## **Hearing Statement from Roads and Transportation Services for**

**Planning Application No:** P/20/1115  
**Proposal:** Erection of Detached House  
**Location:** 45 Hunthill Road, Blantyre, G72 9SR  
**Applicant:** Mr and Mrs Duffy

**Statutory Consultee:** South Lanarkshire Council,  
Roads and Transportation Services,  
Community and Enterprise Resources,  
Roads Development Management Team

### Site Layout

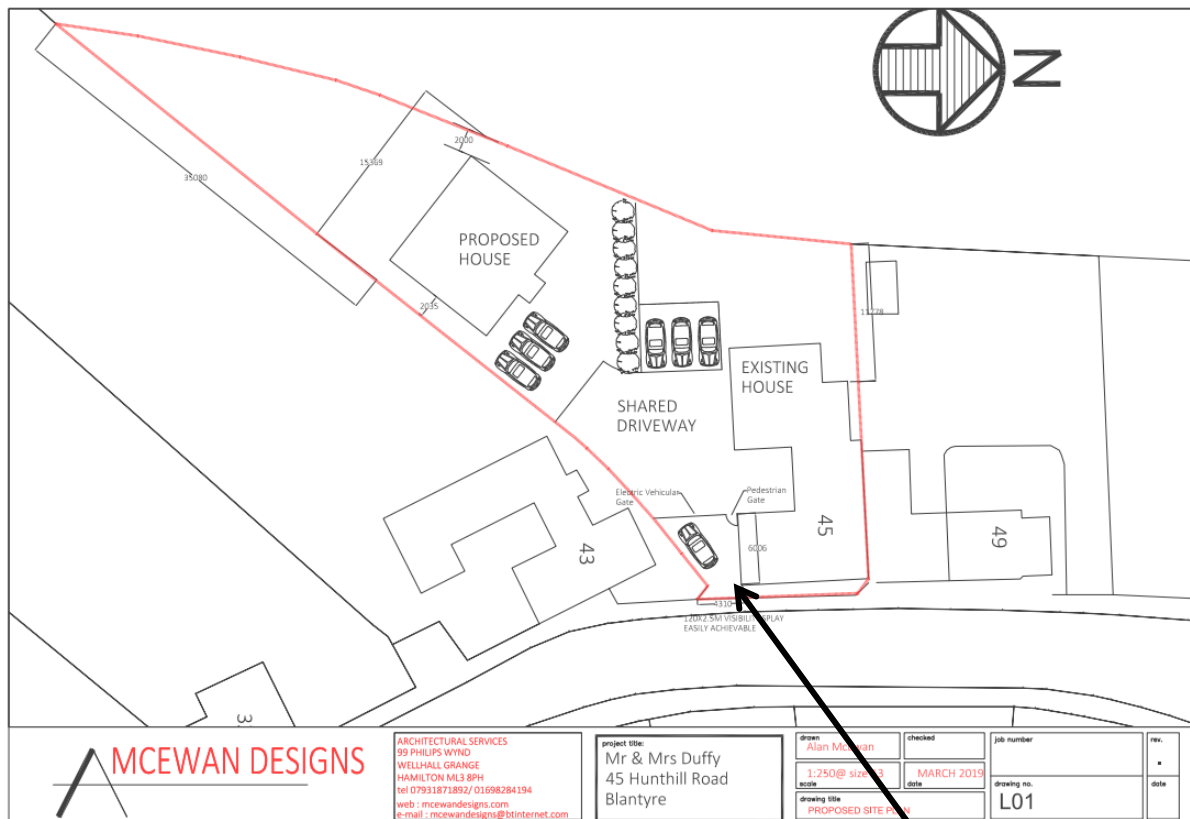
- 2.6 The proposed site plan, drawing L01, shows an access width dimension of 4.13metres at the heel kerb line; the minimum driveway width for a shared access should be 5.0metres. However, the access remains constrained by the existing pinch point referred to above which prevents two-way vehicle movement. The current application does not include any proposal to remove the existing 2.70metre wide pinch point to create a widened shared access.

Note: the pinch point indicated on the architect's site layout, which restricts two-way vehicle movement, is only 2.7metres wide which is less than the 4.31metre dimension shown on the site plan at the heel kerb line.

Photo 3: View looking west towards existing driveway showing curved wall to south

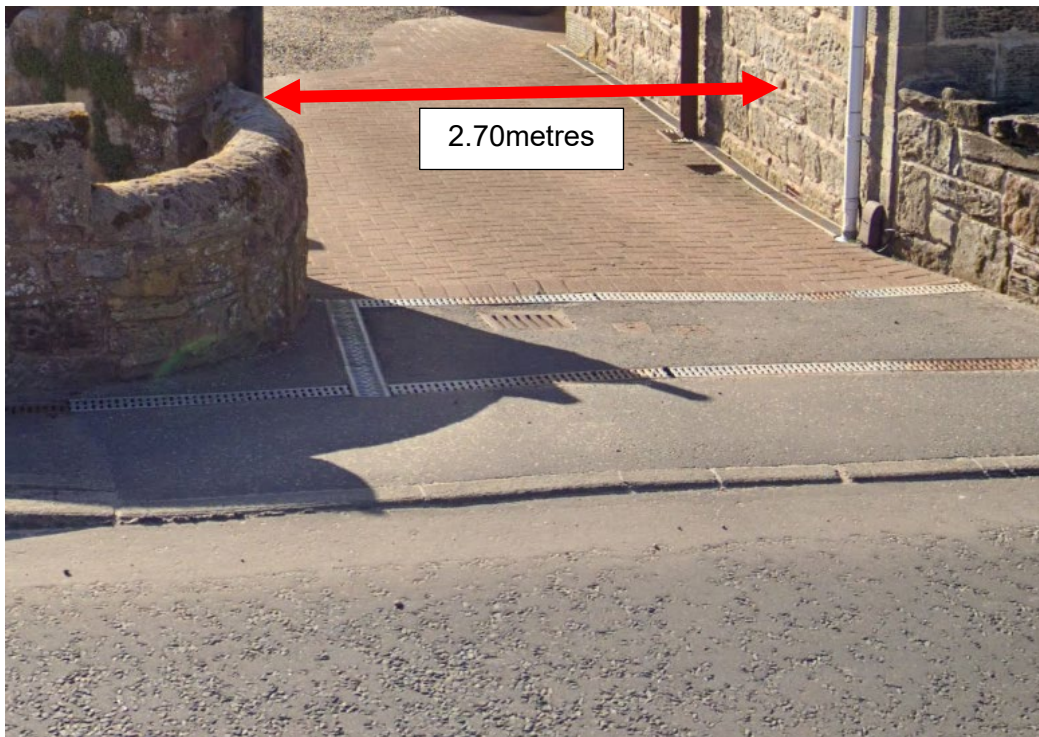
The existing stone wall curves rather than taking a sharp change of direction as otherwise indicated on architect's site plan (see other photo below looking west towards driveway).

Restricted width of 2.7metre wide driveway is well below the Council's requirements of 5.0metres for shared driveways. This arrangement does not provide scope for vehicles to enter/exit the driveway simultaneously.
